PUMP ROOM PLAN

MOTOR ROOM PLAN

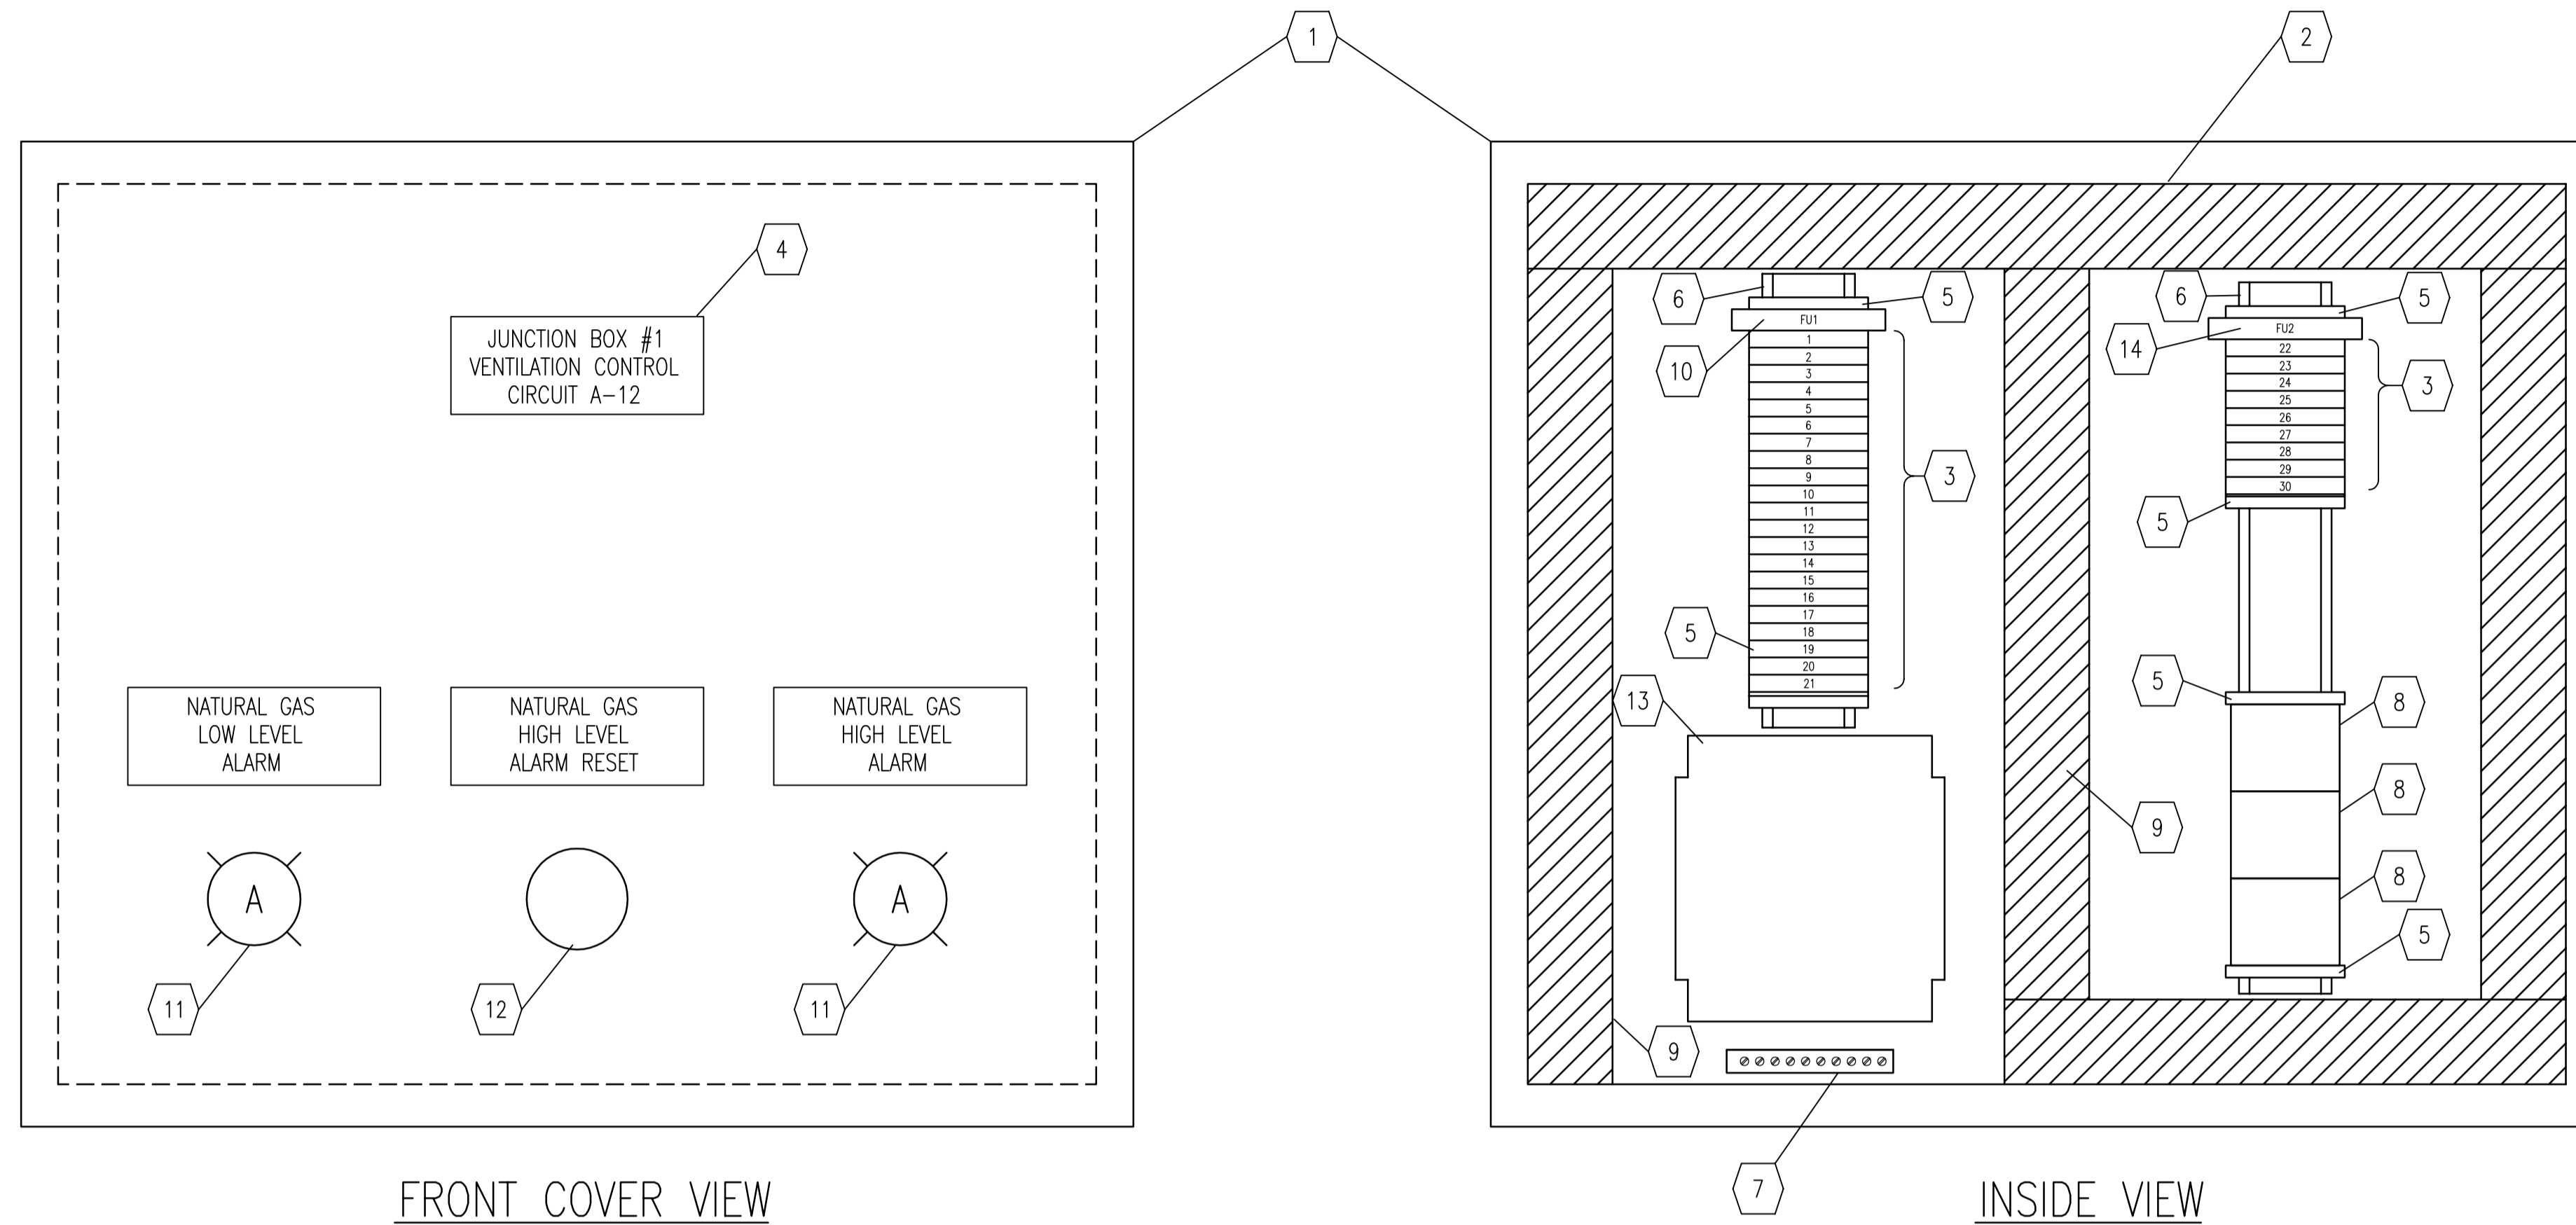
BILL OF MATERIAL				
ITEM	QTY	DESCRIPTION	MANUFACTURER	CATALOG NUMBER
1	1	NEMA 4X JUNCTION BOX ENCLOSURE - 16"x14"x6"	HOFFMAN	A1614CHQR
2	1	BACKPLATE FOR ITEM 1	HOFFMAN	A12P10
3	3	SAK 4/35 TERMINALS	WEIDMULLER SAK4	0443660000
	1	TERMINAL END PLATE	WEIDMULLER	0117960000
	AS REQ'D	TERMINAL MARKERS	WEIDMULLER	0468260000
4	AS REQ'D	PHENOLIC TYPE NAMEPLATE C/W 1/4" LETTERING.		
5	2	TERMINAL END HOLDER	WEIDMULLER EW35	0383560000
6	AS REQ'D	TS35 MOUNTING RAIL	WEIDMULLER	0383400000
7	1	GROUND BAR, 8 TAPS	ILSCO	D167-8
8	4 *	120V, FORM C RELAY, C/W PUSH TO TEST AND LED.	OMRON	MK2PN-S
	3	RELAY OCTAL BASE	OMRON	PF083A-E
	3	RELAY HOLD DOWN CLIP	OMRON	PFC-A1
9	AS REQ'D	WIRING DUCT - NARROW FINGER SLOTTED	PANDUIT	F1X2LG6
10	1	FUSE TERMINAL WITH LED: ASK 1/EN LD 1D 115VAC	WEIDMULLER	0225560000
	3 *	5A FUSE CARTRIDGE		
11	2	AMBER LED INDICATING LIGHT, 120V.	ALLEN BRADLEY BULLETIN 800H	800H-QRH10R
12	1	PUSHBUTTON, NEMA 4X	ALLEN BRADLEY BULLETIN 800H	800H-GR2A
